**Proposed Decision to be taken by the  
Portfolio Holder for Transport and Planning  
on or after 23 August 2019**

**High Speed Two Phase 2b Design Refinement Consultation**

## **Warwickshire County Council's response to the High Speed Two Phase 2b Design Refinement Consultation 2019**

# APPENDIX B1

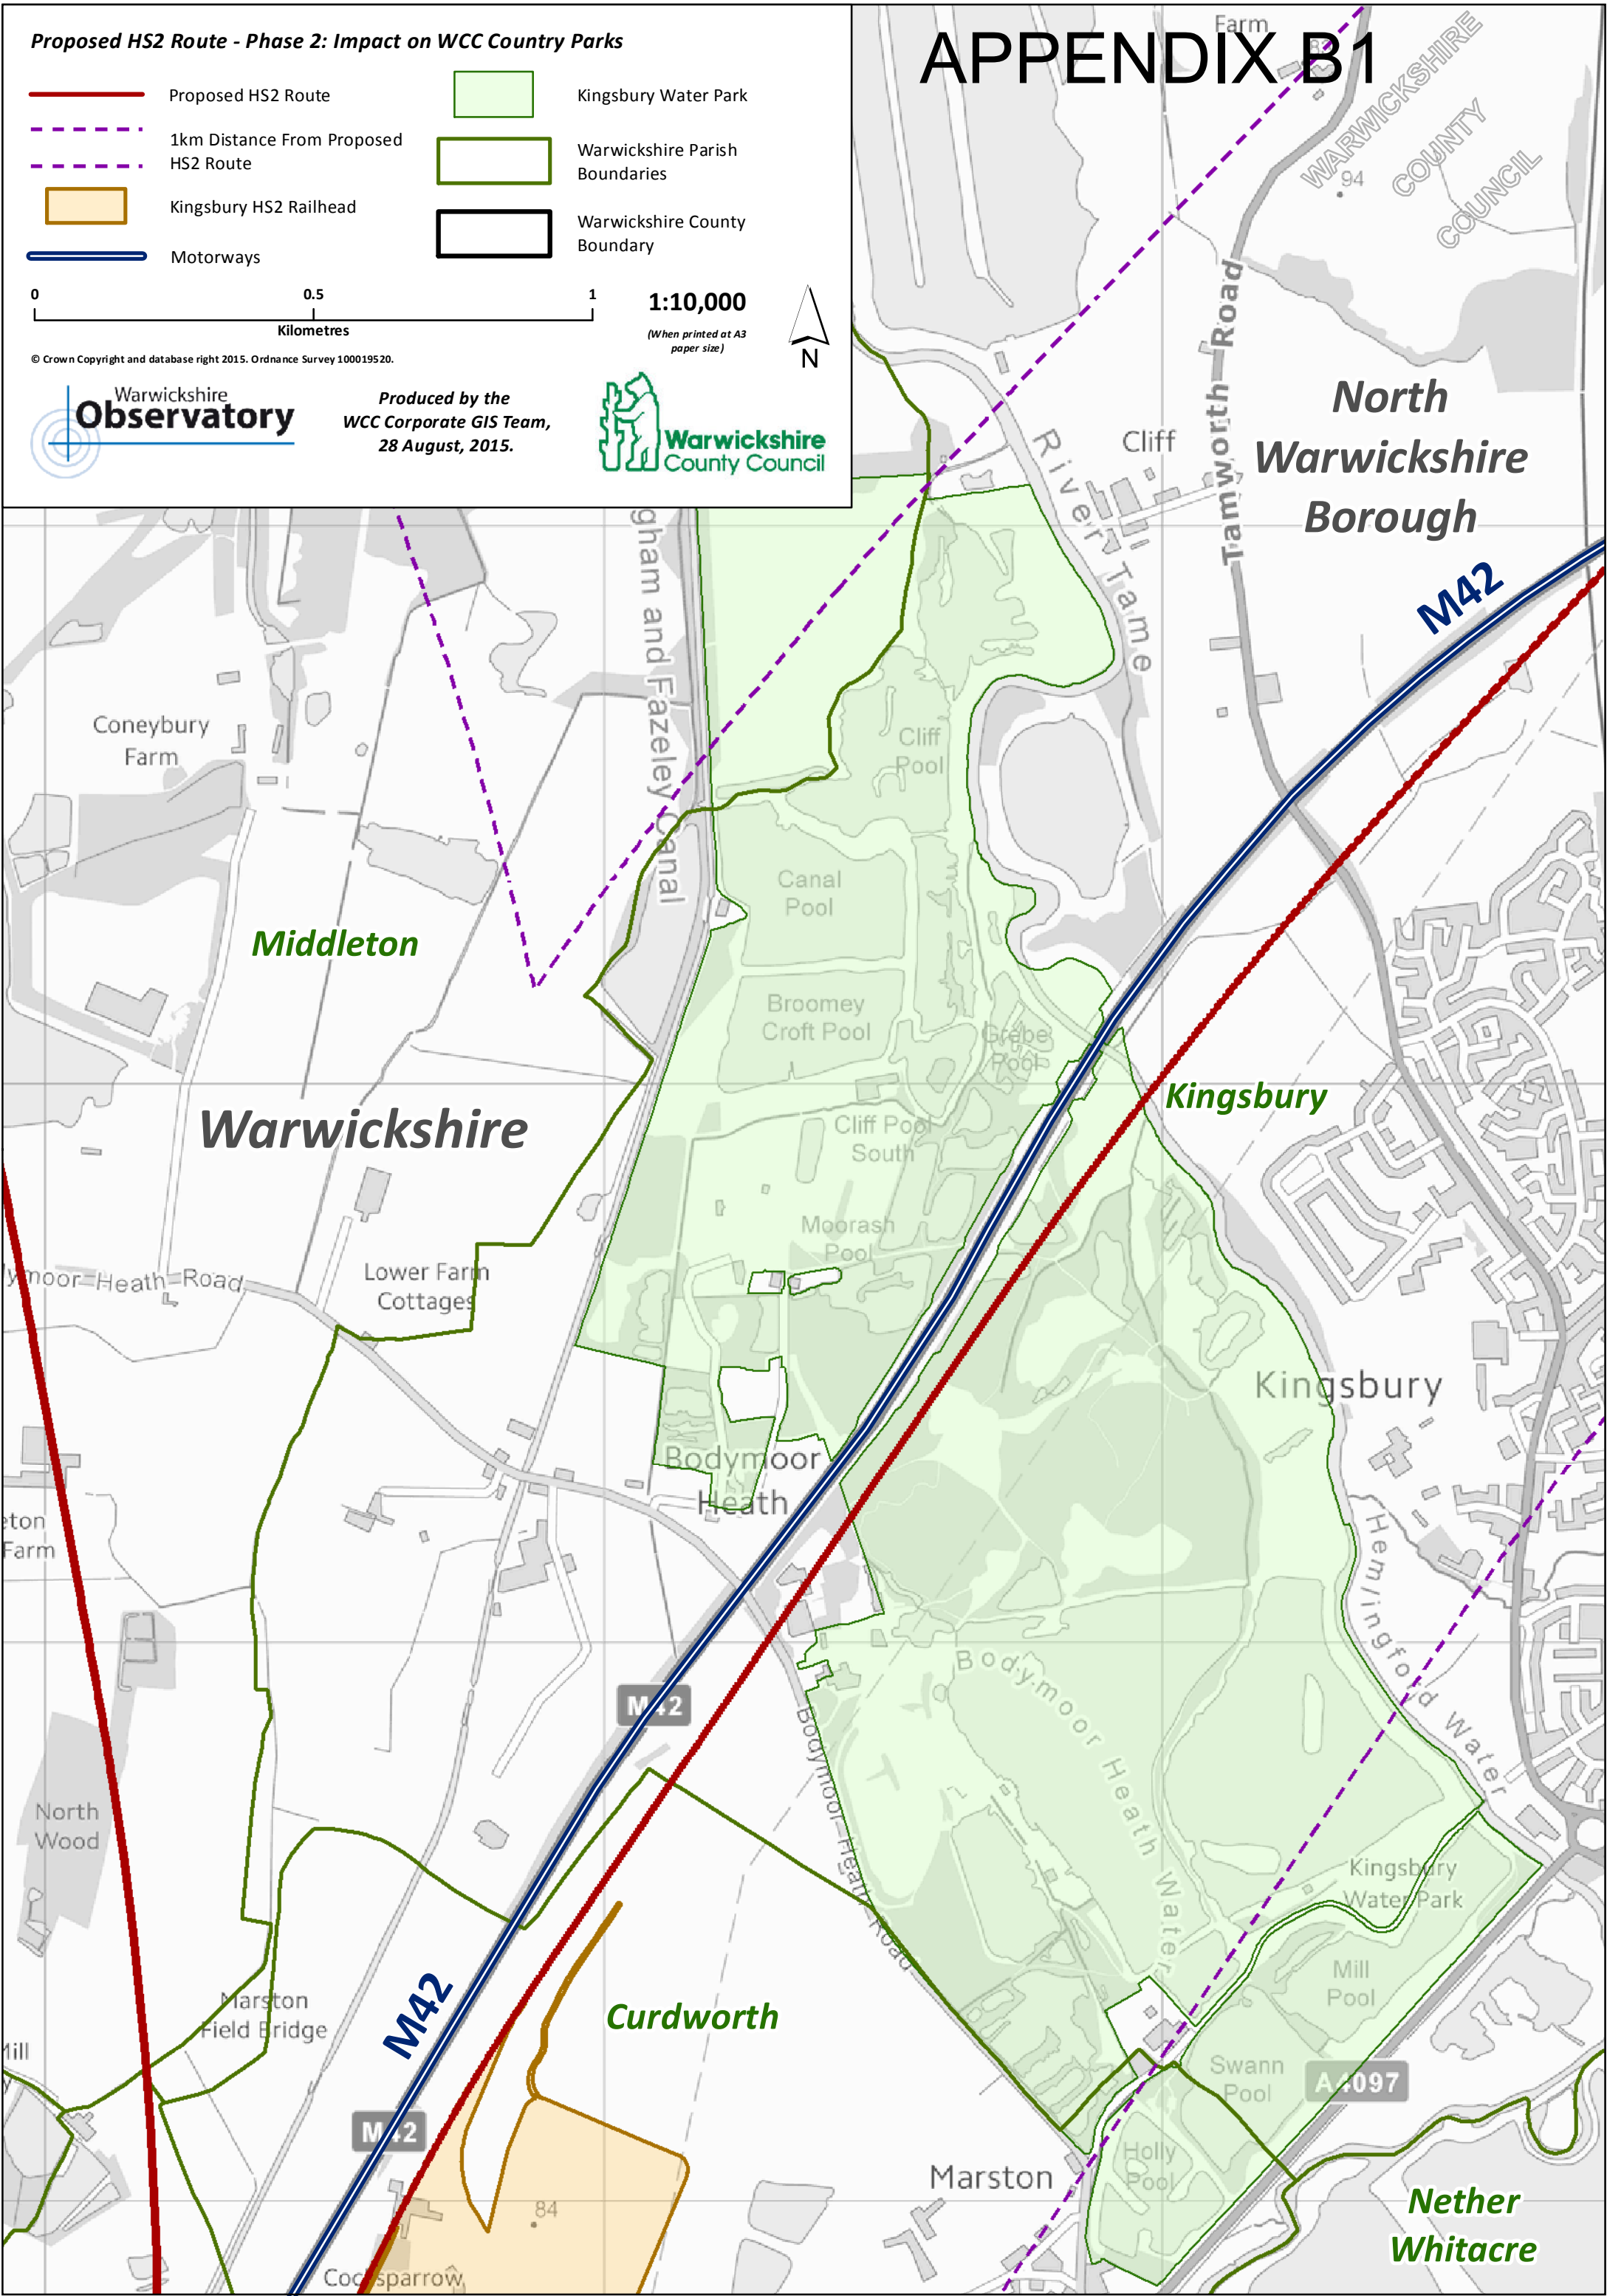
3.1 The council acknowledges that the changes associated with HS2 Ltd's tunnel proposal will cause a permanent detrimental effect on Kingsbury Water Park (KWP). To date no mitigation measures have been proposed by HS2 Ltd in response to ongoing concerns raised by the council in previous consultation responses.

3.3 The effect of the design amendment to lower the track bed height through the park makes the rail infrastructure, and its construction, more intrusive than the previous plans. The change to a 1km embankment, before resuming as viaduct, has a negative impact on the visitor experience and is impermeable to movement of people and wildlife around the park.

3.8 The additional embankment and construction road in the park presents a greater ecological impact than HS2's previously suggested design. The park is home to a regionally and nationally significant habitat, the impacts on which are not sufficiently mitigated by the current proposals. Full mitigation for this loss through more ecological habitat provision, immediately adjacent to and accessible from the park, is required.

3.6 The council envisages the most viable option is to move the visitor hub facilities away from the construction area of HS2. The council requests HS2 Ltd to deliver an equivalent alternative provision within the park in advance of HS2 construction works that enables the railway to be built and operated without severe detriment to the park as a whole.
